# TOLEDO-LUCAS COUNTY PLAN COMMISSIONS

REF: SUP-11004-17

SUBJECT: Amendment to a Special Use Permit, originally granted by Ord. 149-16, for Community Recreation, Active

Request	-	Amendment to a Special Use Permit, originally granted by Ord. 149-16, for Community Recreation, Active
Location	-	1302 Linden Lane
Applicant	-	Al-Madinah Community Center 3151 Chollett Drive Toledo, OH 43606
Architect	-	Tadd Stacy Architecture by Design 5622 Mayberry Square Sylvania, OH 43560
Engineer	-	Bryan D. Ellis, P.E., P.S. Glass City Engineering & Surveying 2001 River Road Maumee, OH 43537

# LANDSCAPE PLAN

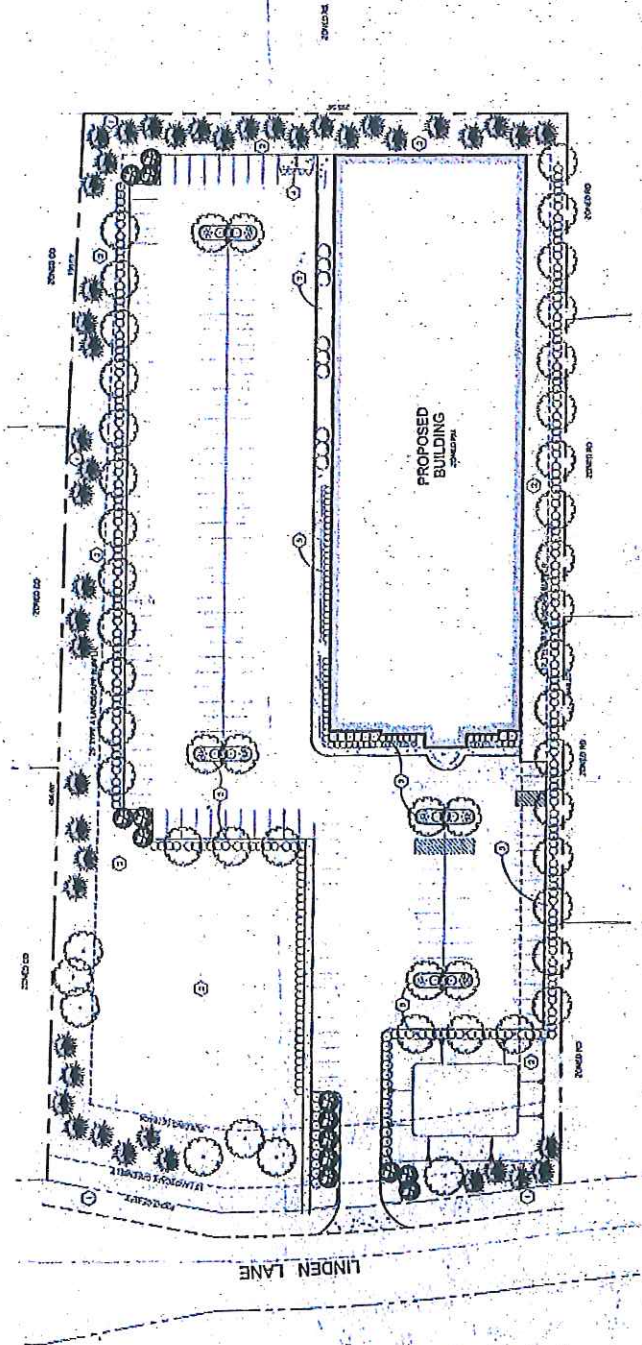
The landscape plan provides a 15 foot frontage greenbelt, a Type A buffer to the north, a 25 foot landscape area to the east, a Type B buffer to the south, interior/perimeter parking lot landscaping, foundation plantings, and interior site landscaping. The frontage greenbelt and Type A buffer do not meet quantity requirements within the required buffer areas, but meet the spirit of the code when counting overlapping parking lot and interior planting requirements in the extended green space between both areas. A 25 foot setback to the east is required as part of the PUD, but a Type A buffer is not required due to the adjacent RM36 zoning. Additionally, the Type A buffer to the north is shown at 10 feet adjacent to the library, but does not provide the required privacy fence. The applicant asked if the privacy fence on the library parcel could also be counted to meet the Type A requirement on their parcel instead of installing a second fence against the existing fence. Staff is supportive of this request provided that fencing be installed if the library fence is ever removed.

The landscape plan is compliant except for the follow areas: interior/perimeter parking lot landscaping and interior site landscaping. The interior parking lot does not provide the required area and plantings and the perimeter parking lot must include the installation of a solid row of shrubs along the easternmost row of parking spaces. A revised site plan was submitted that complies with interior landscaping spacing, however required plantings and area must still be verified. Interior site landscaping requires one tree for every 500 square feet of building area. This requires an additional 81 trees on the property.

- e. A 10' Type A Buffer is acceptable along the northern property line adjacent to the library without a fence. The adjacent parcel provides a privacy fence. If the adjacent fence is ever removed the applicant shall install the appropriate Type A buffer fencing along this area. **Shall be submitted on a revised landscape plan.**

a. Total interior landscaping shall be 3,280 sq. ft and include a total of 33 trees and 99 shrubs. All parking spaces shall be within 100 feet of interior landscaping areas.

b. Landscaped terminal islands must be provided for the parking rows south and east of the open space parcel.

- c. An additional 81 trees shall be installed to meet the interior site landscaping requirements.
  - d. A solid row of shrubs shall be installed along the easternmost row of parking spaces.

# ELEVATIONS (COLOR)

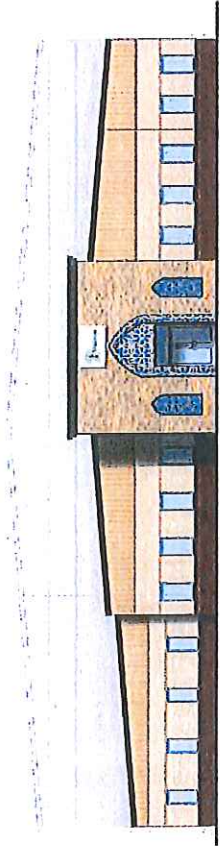
The design of the building is divided into two parts: the community center and the gymnasium/soccer field. The community center is designed with elements that largely meet the design guidelines, however the use of metal siding is typically only approved as an accent material and shall be reduced along the eastern façade. The gymnasium/soccer field does not meet the design guidelines for the massing of the building or the use of high quality materials. The gymnasium predominantly uses metal siding on all four sides and provides limited architectural variation with a translucent banded panel around the top of all four facades and the use of sports graphic along the north elevation. The sports graphics are considered wall signage and are not permitted in the zoning district.

Revised elevations were submitted that removed the metal panels from the western façade of the community center and added a 40" high founders brick wainscot around the entire base of the gymnasium. They have also removed the proposed sports graphics and added canopy trees around the perimeter of the gymnasium/soccer field to break up the massing of the building. Staff does not feel that these efforts are enough given the size or visibility of the building and context of both the adjacent residential and commercial structures. There are no metal panel buildings in the nearby vicinity and a building with scale and visibility would not fit with the neighborhood.

Staff recognizes the challenges associated with a project of this scale and is willing to work with the applicant on the required design criteria, but the project should take further steps to be more compatible with the design standards and the surrounding area. Additional vertical and horizontal elements have been requested along with a reduction in the use of metal panels and an increase in the use of materials that are more compatible with the surrounding area.

Approve a waiver of the required design elements for the north, west, and south elevations provided the elevations incorporate additional vertical and horizontal elements for the gymnasium subject to the review and approval by the Plan Director.

Disapprove a waiver to allow metal panels as a predominant building material for north, west, and south elevations.

32. High quality building materials must comprise at least 75% of the total wall area for the north, west, and south elevations. Metal paneling is not an acceptable high quality material and shall be used only as an accent. Founders brick is an acceptable high quality material provided the height of the brick does not exceed 4 inches. **Shall be submitted on revised elevations. Applicant must obtain a waiver of TMC 1109.0501.A or comply fully with the requirements of said section.**
